DRAWN BY: PDZ	ZUNI RENTALS DRAINAGE & PLOT PLAN
CHECKED BY: RLH	
REVISIONS: TENTATIVE (Mar 9, 1981) (Feb 4, 1981) REV. 10/27/81	SUPERIOR CONSTRUCTION CO.
RAY HARRISON & ASSOCIATES	SHEET 1 OF 6

City of Albuquerque
Mr. Christopher Weiss
CTS, Inc.
1100 A Alvarado SE
Albuquerque, NM 87110
January 31, 1985
REF: ZUNI RENTAL ADDITION LOTS 1-5, LAHR SUBDIVISION SOUTH 200' OF TRACT G (DRAINAGE) RECEIVED JANUARY 10, 1985
Dear Chris:
Based on your information as presented to our office, free discharge of the above referenced drainage is acceptable. We have contacted your clients and advise them of the new requirements. Our office will work as quickly as possible on their decision. Also, review of the residential will be handled as priority.
If you have any questions or comments, please feel free to contact me at 766-6482.
Sincerely yours,
Hydrology Section
Civil Engineer/Hydrology

DRAINAGE / GRADING PLAN
ZUNI RENTAL ADDITION
2705 PRINCETON N.E.

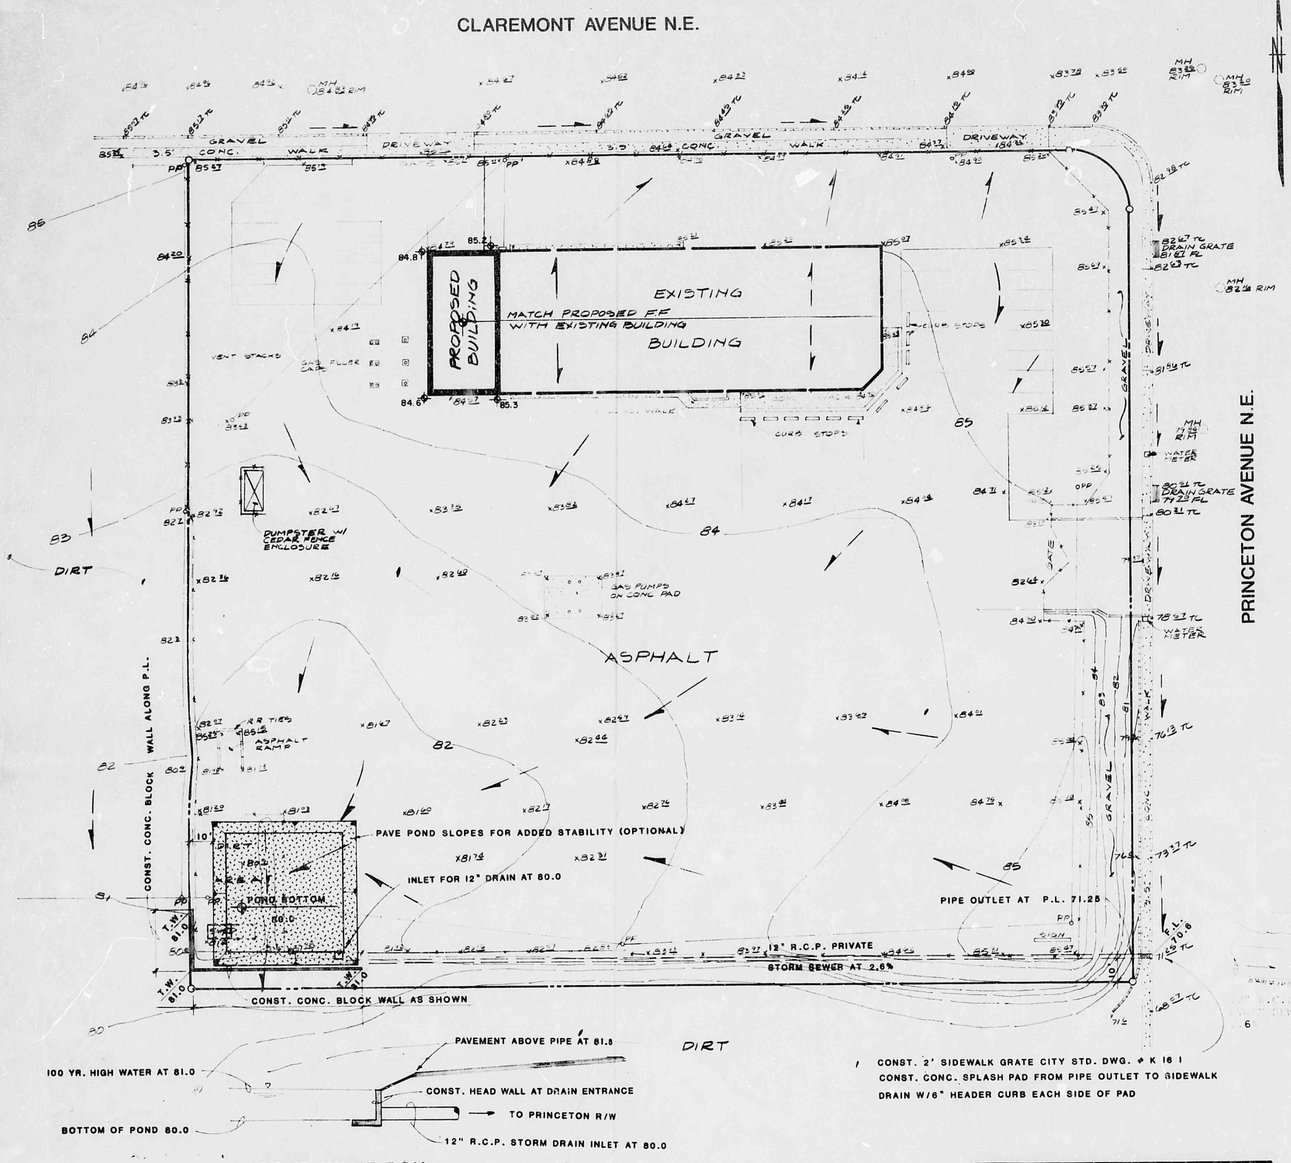
RESUBMITTAL 1-24-85: REVISED POND TO FREE DISCHARGE.

Max discharge rate for 12"R.C.P. at 2.91% slope = 7 c.f.s.
Peak rate to S.W. Corner of site = 12 c.f.s.
Max. vol. to be detained = 3000 cu. ft. for the 100yr. event. - Full free discharge from site limited by pipe slope and size. Property owner is willing to construct shallow pond at S.W. corner of site to serve as detention collection area for runoff rather than increase pipe size to a larger diameter.

POND ADDED IN S.W. CORNER W/ 12" OUTLET PIPE TO PRINCETON, & APPROPRIATE DETAILS.

Pond area (top dimensions) = 60' x 40'
S.S. = 3:1 (Max.) Depth = 1.0', in pond,
Vol. available = 3100
Outlet under head of 1.0'
Pipe Capacity = 7cfs at 2.6% slope

TOTAL: 3100 cu. ft.
VOLUME REQUIRED: 3000 cu. ft.
